UNITED STATES
NUCLEAR REGULATORY COMMISSION
WASHINGTON, D.C. 20555-0001

SUBJECT: REQUEST FOR ADDITIONAL INFORMATION (RAI) RELATED TO THE AP600
WGOTHIC REVIEW AREA

WGOTHIC Review Requests For Additional Information

AP600 - REQUEST FOR ADDITIONAL INFORMATION ON WCAP-14407,
SECTION 13, "WGOTHIC NODING STUDIES IN SUPPORT OF THE
AP600 EVALUATION MODEL"

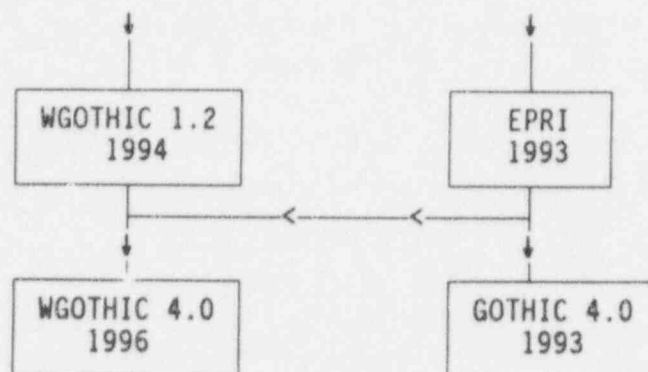
480.488 A comparison of this description to the description provided in WCAP-14382, which refers to version 3.4 of the GOTHIC family, when combined with responses to NRC concerns with known code errors as discussed in EPRI RA-93-10 (see Westinghouse letters NTD-NRC-95-4577, October 12, 1995 and NTD-NRC-95-4595, November 13, 1995) leaves at question the exact parentage of WGOTHIC 4.0. Is WGOTHIC based on version 3.4 with known code errors corrected or is it based on version 4.0? Figures 3-1 and 13-1 should be revised as appropriate, for example:
